The Beach – Apollo Bay

Development Plan Summary

17 January 2018

Beveridge Williams Melbourne Office 1 Glenferrie Road Malvern Vic 3144 PO Box 61 Malvern Vic 3144 Tel: (03) 9524 8888 beveridgewilliams.com.au	Title	Development Plan Summary
	Author	Leanne Nickels
	Checked	Mark Fleming
	Project Manager	Bernard Stewart
	Synopsis	Brief report discussing the revised development plan

APPENDIX A. Proposed Development Plan

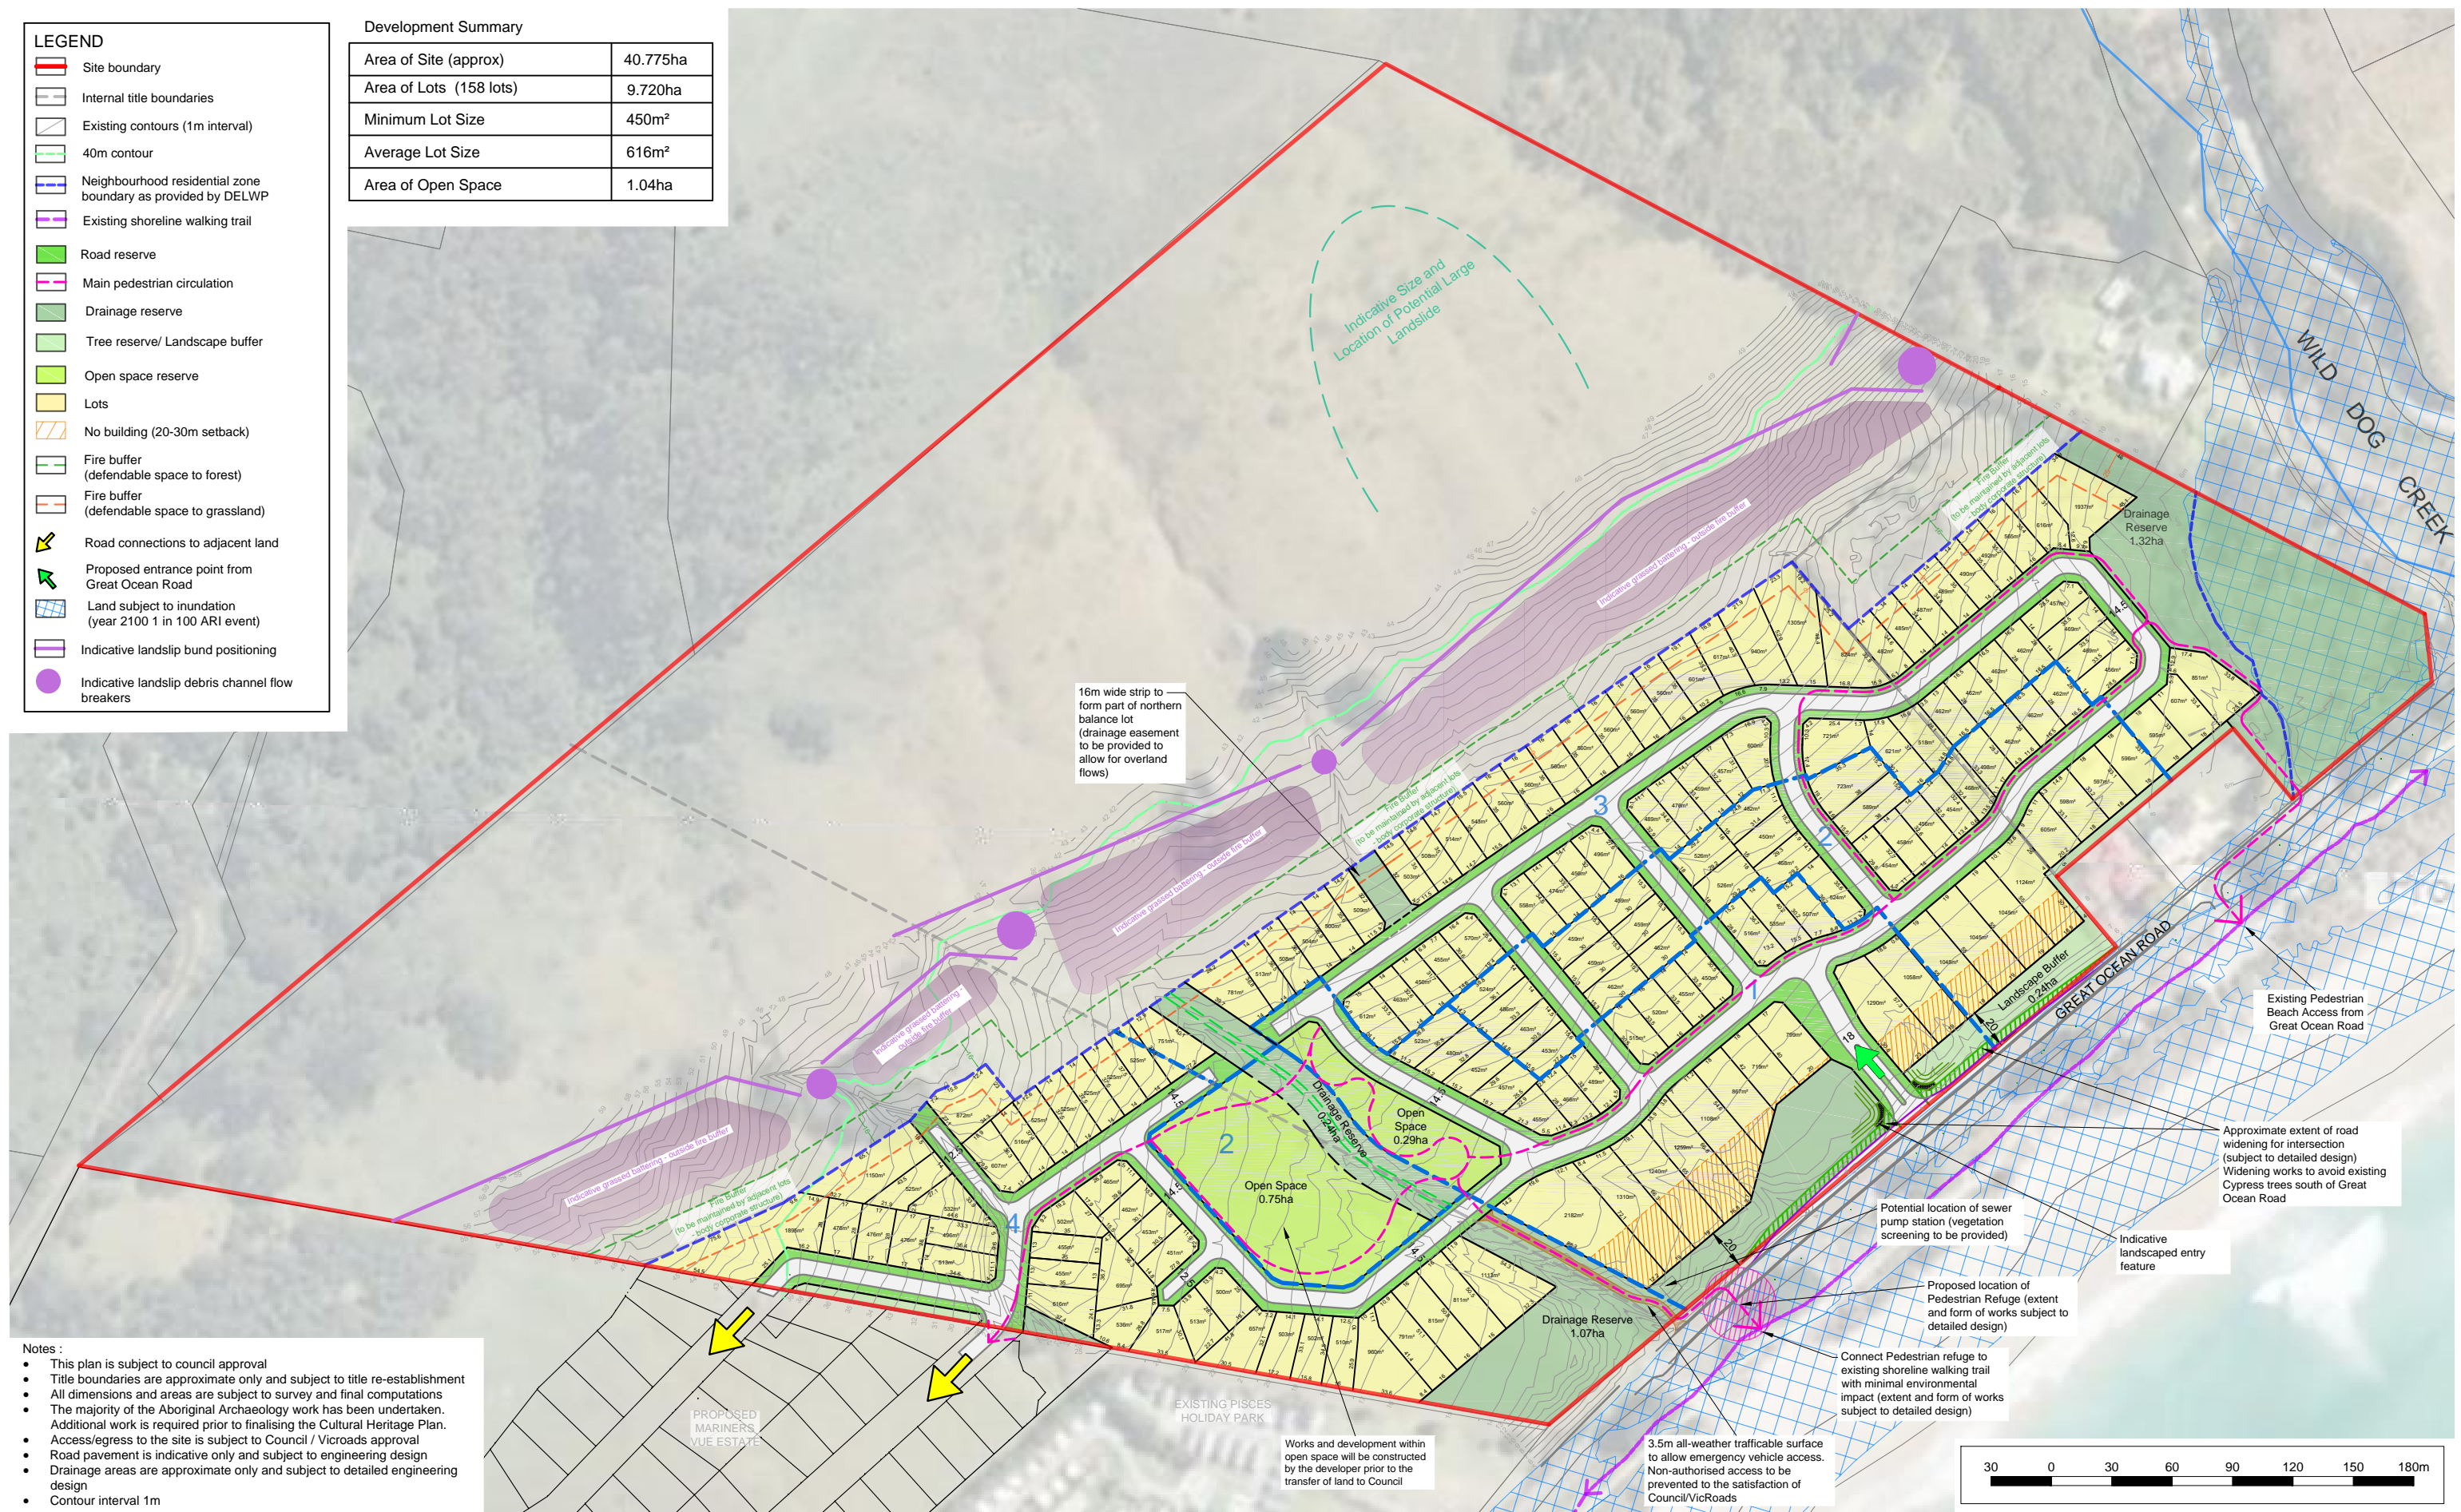
After meeting with Council in November 2017, the development plan has again been revised, and is now at Version 25. The main changes concern the drainage channel through the centre of the open space, and the removal of the lot above the 40m contour. The changes are discussed in further detail within the following sections of this report.

DPO5 makes mention that development should not occur above the 40m Contour. We request that Council review this requirement, in light of the Neighbourhood Residential Zone encompassing a small pocket of land above the 40m contour in the west of the site.

2.3a Response following meeting with Council – November 2017

Following discussions with Council regarding this matter, the development plan has been amended to show land above the 40m contour contained within a single lot, which also has sufficient area for a dwelling to be constructed below the 40m contour.

APPENDIX B. Cross Sections along Great Ocean Road

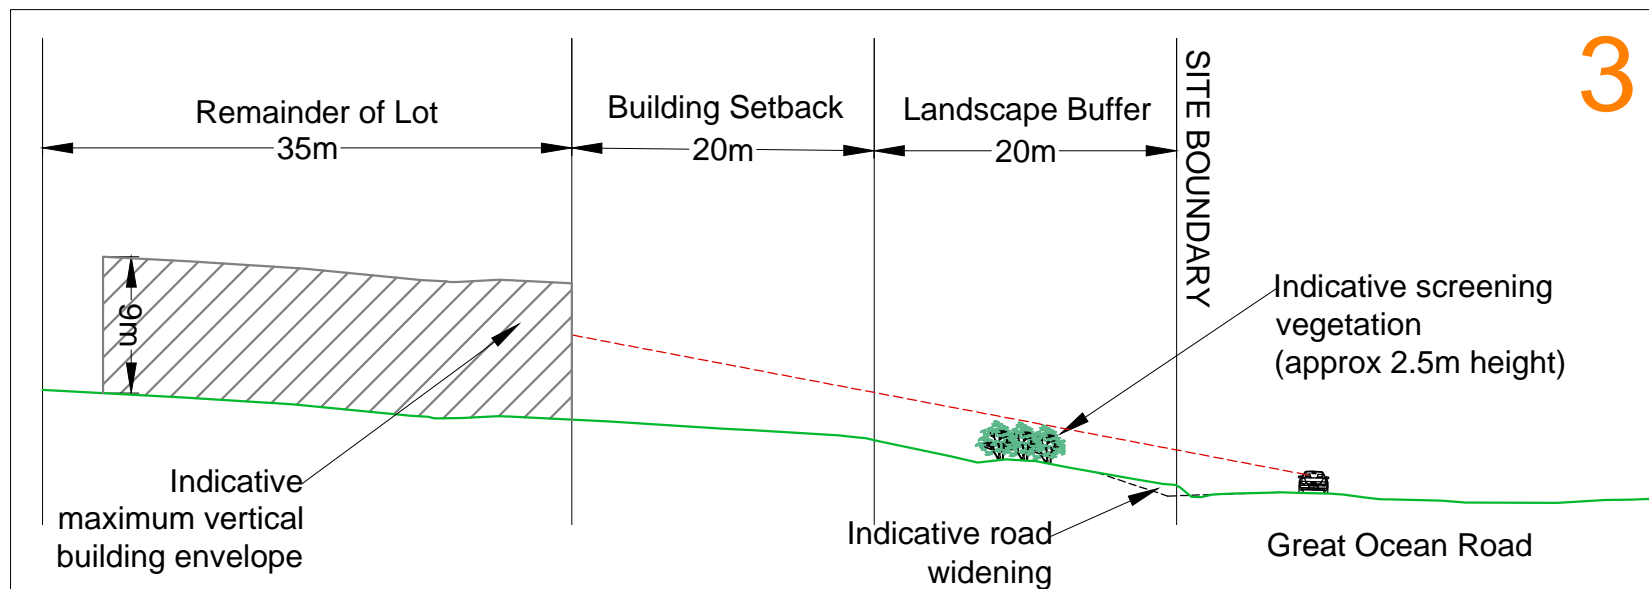
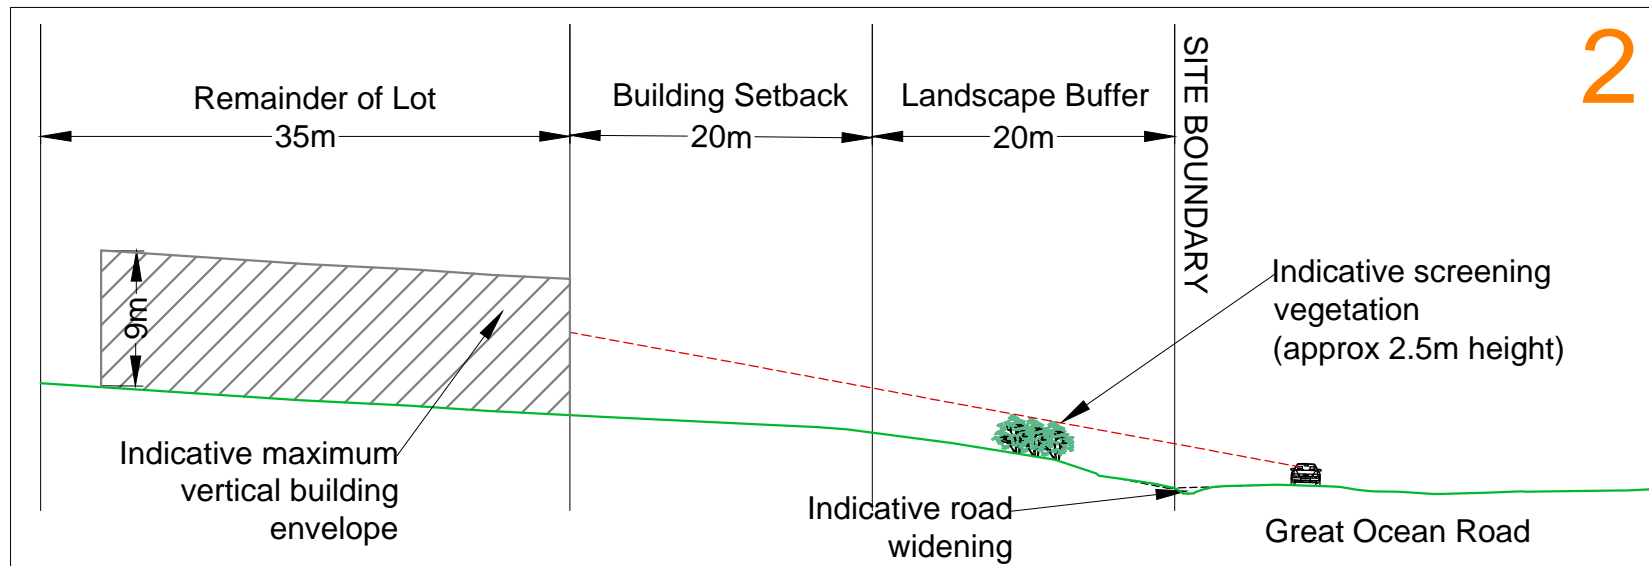
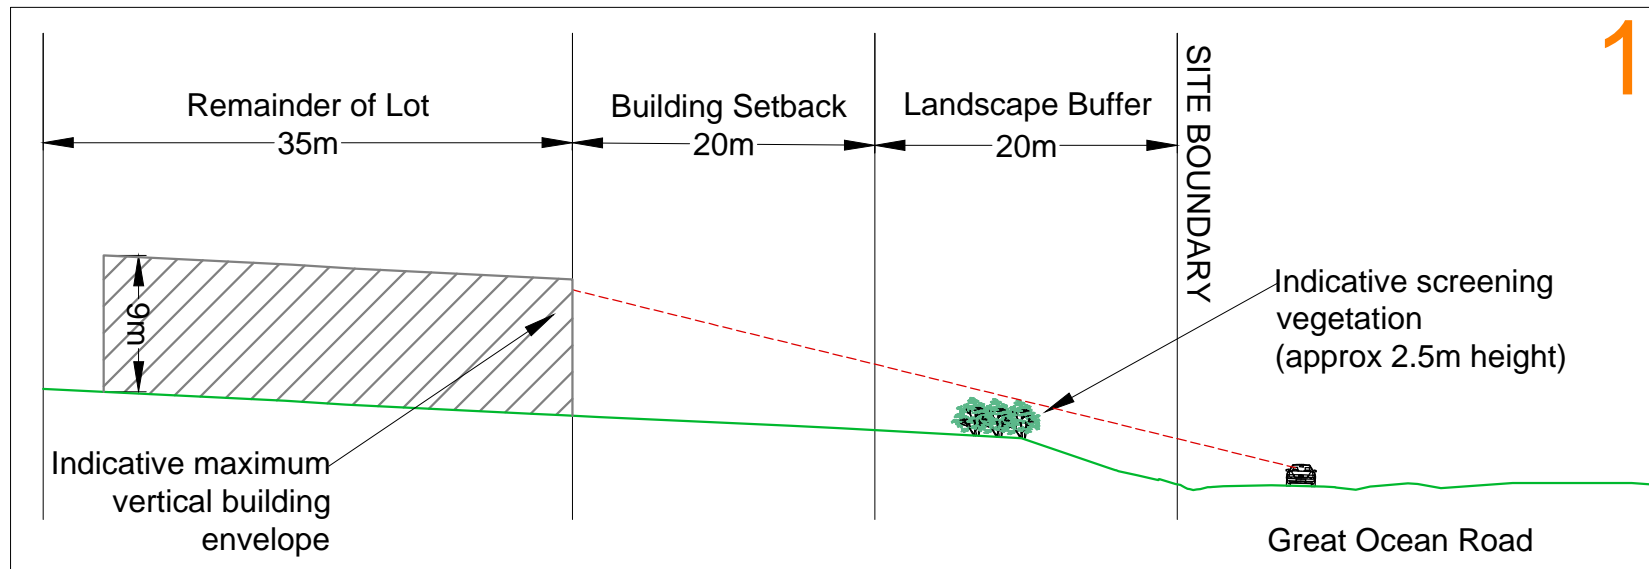
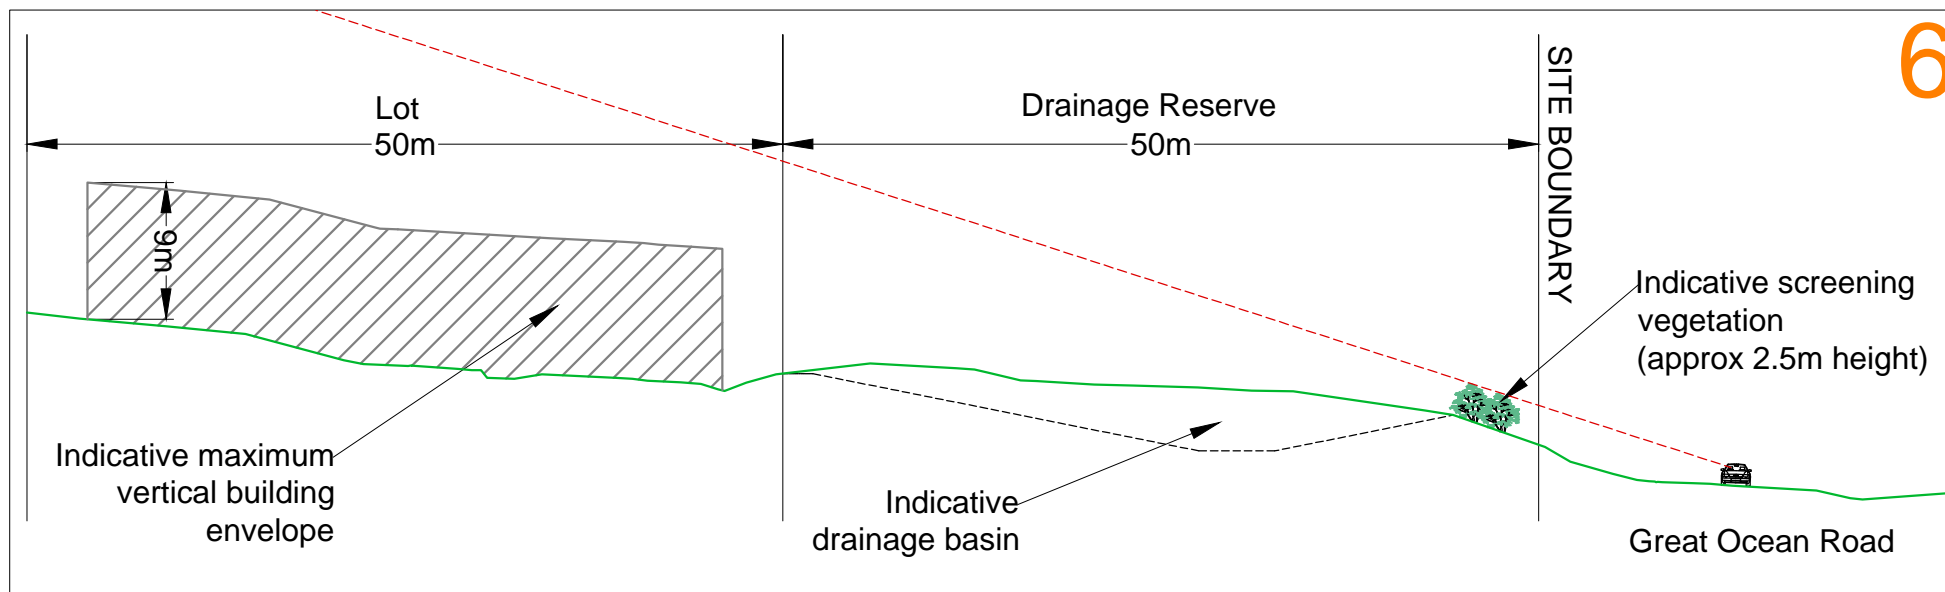
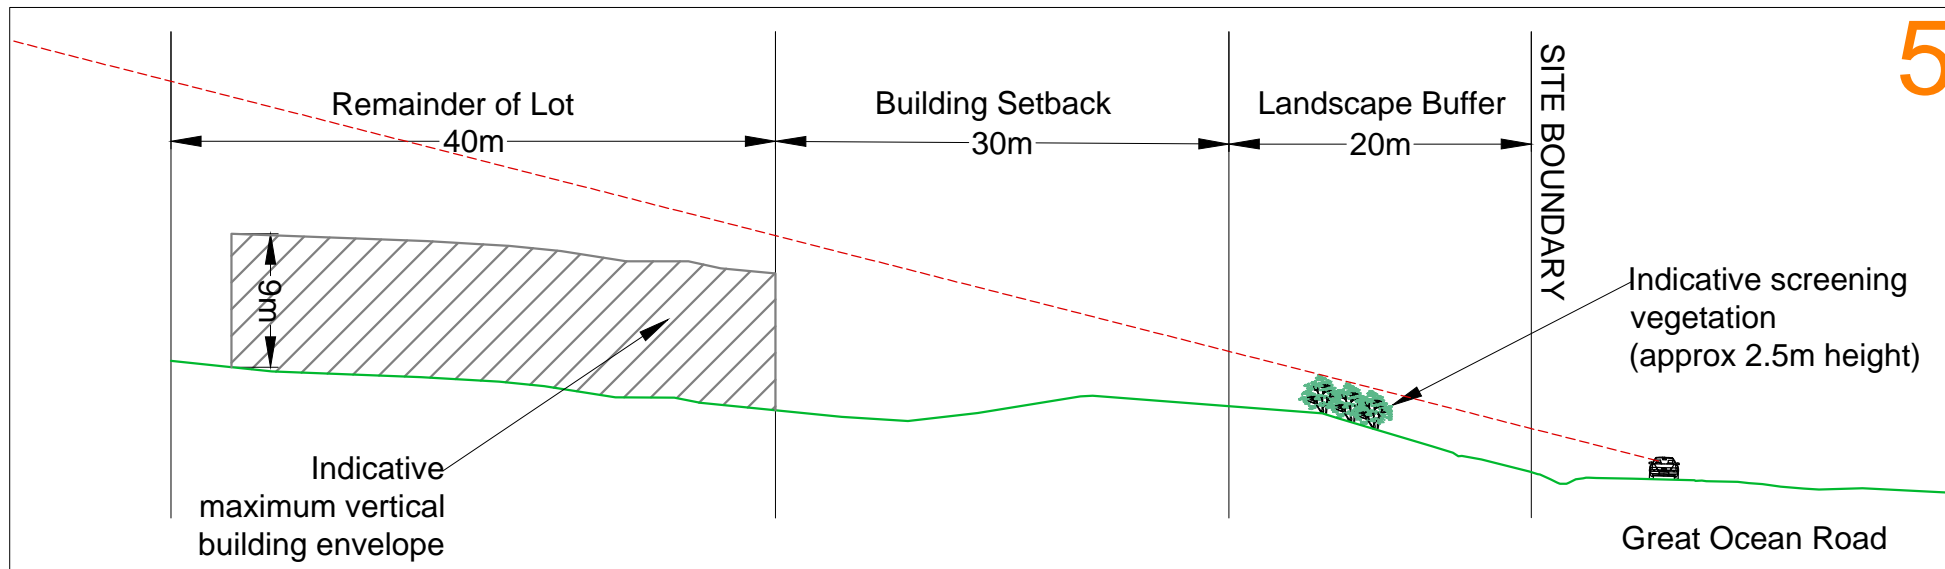
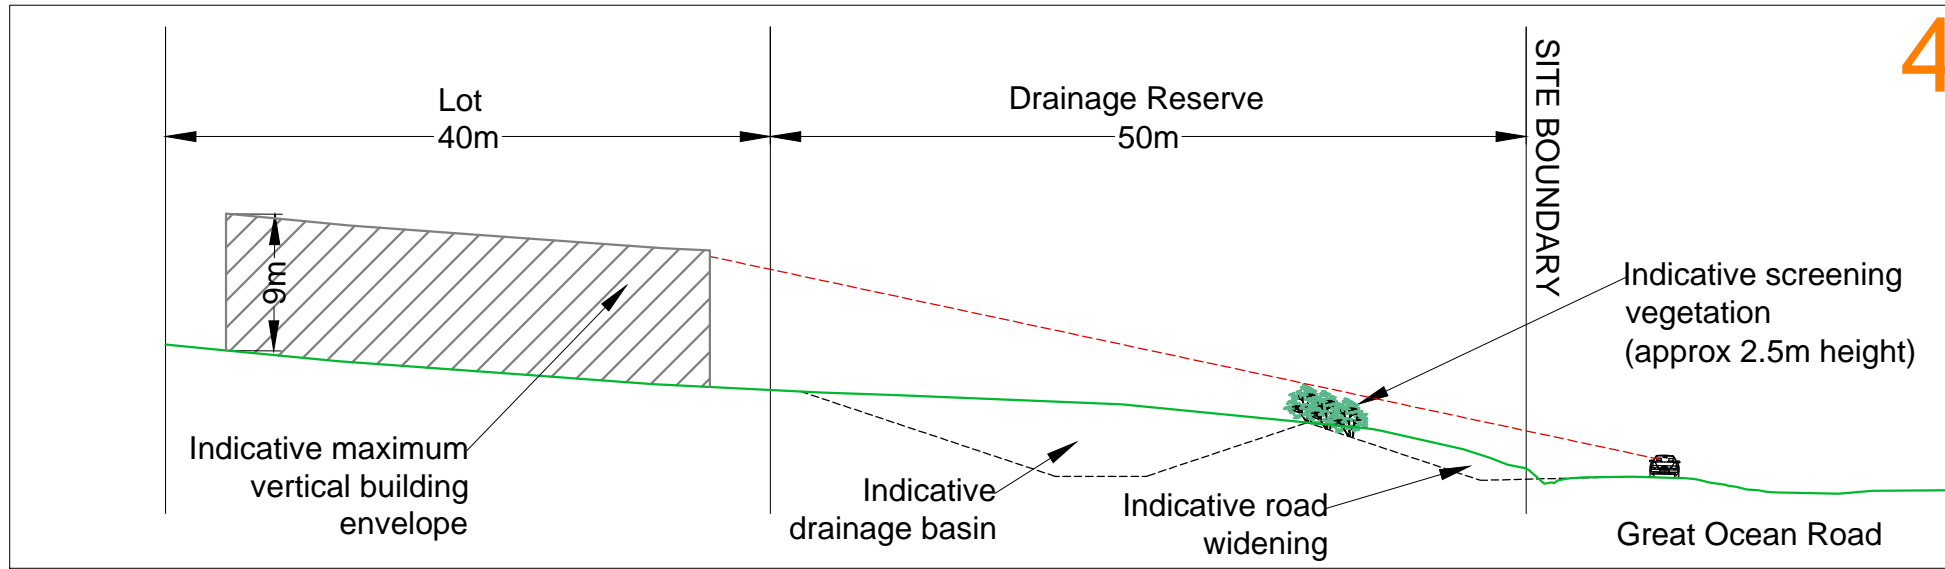
An assessment of the visibility of any potential housing fronting the Great Ocean Road has been undertaken – refer Appendix B.

It is proposed to provide “no building” setbacks of between 20m and 30m, depending on the depth of the block, and to provide vegetation along the landscape buffer and drainage reserves along the Great Ocean Road frontage, which will grow to a height of at least 2.5m

The attached sections demonstrate that, at worst, approximately the top 3.5m of housing on 6 lots will be visible from vehicles travelling along the great ocean road (lots east of proposed entry road).
